TRANS/WP.29/GRRF/2002/24
5 July 2002

World Forum for Harmonization of Vehicle Regulations (WP.29)

PROPOSAL FOR DRAFT AMENDMENT TO REGULATION No. 79

Transmitted by the Expert from Poland

Fig. 1 The example of characteristic of work of the steering system $F=f(\delta_H)$ obtained from measurements during the vehicle driving with the constant speed $v=10$ km/h.

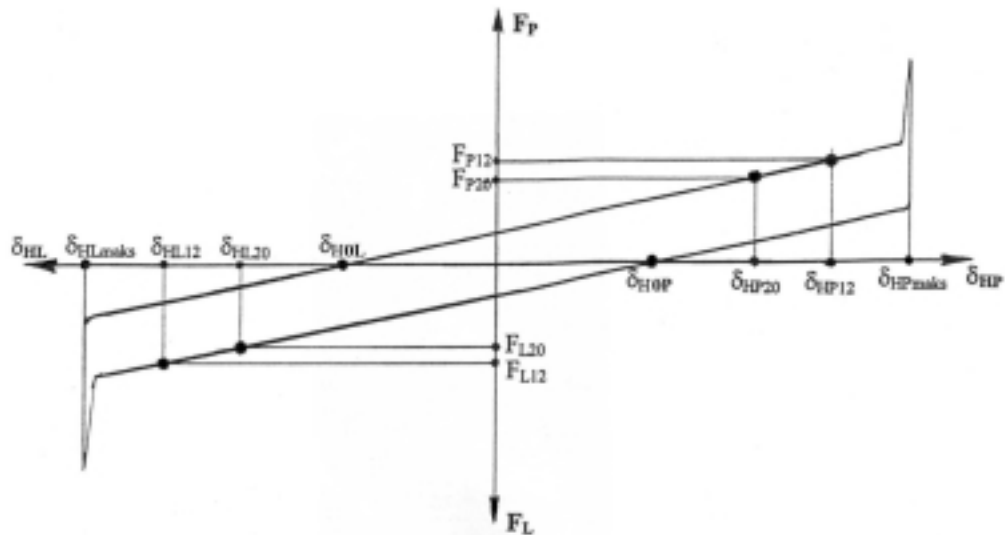
6.2.2. The measurement of the steering effort of vehicles.

The steering effort of vehicle should be determined on the base of the work characteristic of the steering system $F=f(\delta_H)$ expressed by the relationship between the control effort on the steering wheel F and its turn angle δ_H . This relationship should be obtained by the measurement of the force F and the angle δ_H during the determined change of the direction of vehicle driving with the constant speed $V=10$ km/h (Fig. 1).

The start of the measurements and records of the force F and angle δ_H should be followed after the vehicle drove on the circle at the maximum turn of the steering wheel.

Starting from this position the steering wheel should be turn with the constant speed ($d\delta_H/dt$) in opposite direction until it accomplishes the full opposite position.

After the temporary stop of the steering wheel the direction should be changed maintaining the same constant rotary speed to the maximum (original) turn angle.

During these measurements the absolute rotary speed of the steering wheel should be selected from the range between $20^\circ/s$ to $50^\circ/s$ and kept constant in both directions of the steering wheel.

Starting from the max turn of the steering wheel in right direction it should be made at least two measurements and then should be done the same from max turn position in left direction.

Measurements should be made with the intact steering system and system with a failure where is applied the power assisted device. The steering effort is read out from characteristic $F=f(\delta_H)$ as the average value of forces related to the turn angle of the steering wheel when the vehicle is driving into the bend with the outer contour radius $R=12$ or 20 m to right and left direction according to requirements included in the table below. During the measurement of control effort, forces with duration of less than 0.2 records shall not be taken into account.
